# Service Letter No. 66

FAA: Cham  
Rev. B: MAY 18 2006

**SUBJECT:** Attach bolts for spring gear and trigear models

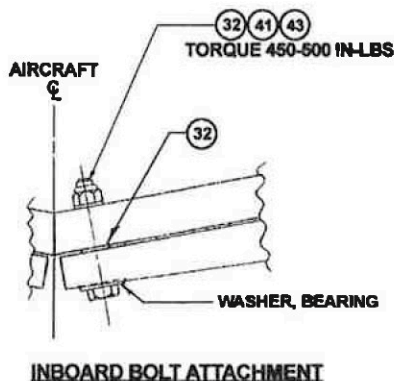
2) Install the following per **Detail -2:**

- (39) 2 ea. 4139B-1 Main L.G. Attach Strap, Upgross
- (40) 4 ea. NAS6606-44 Bolt, High Strength
- (42) 4 ea. MS21042-6 Nut, High Strength
- (31) 12 ea. MS-20002-6 Washer

**Note:** Retorque bolts after 25 hours and per Maintenance Manual thereafter.

**Note:** The maximum combined height of washers that should be used is 1/8 inch and should have at least one thread of the bolt protruding through the nut.

**Detail -1**

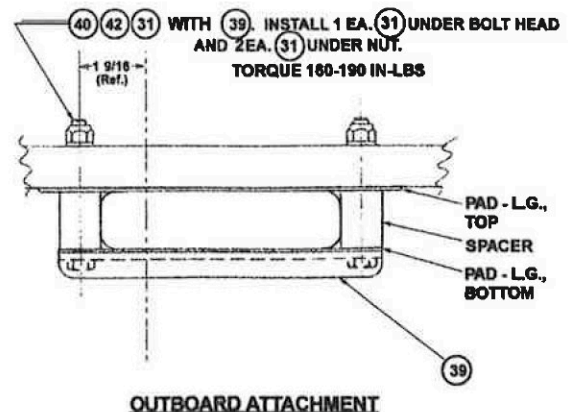
1) Install the following per **Detail -1:**

- (32) 4 ea. MS-20002-7 Washer - Flat
- (41) 2 ea. NAS6607-27 Bolt, High Strength
- (43) 2 ea. NAS1291-7 Nut, High Strength

**Note:** Apply LPS 3 (Rust inhibitor, Heavy Duty) liberally during assembly of inboard bolt attachment – to bolt holes and washer surfaces – to bolts, nuts and washers – also applies to outboard attachment and axle assembly attachment.
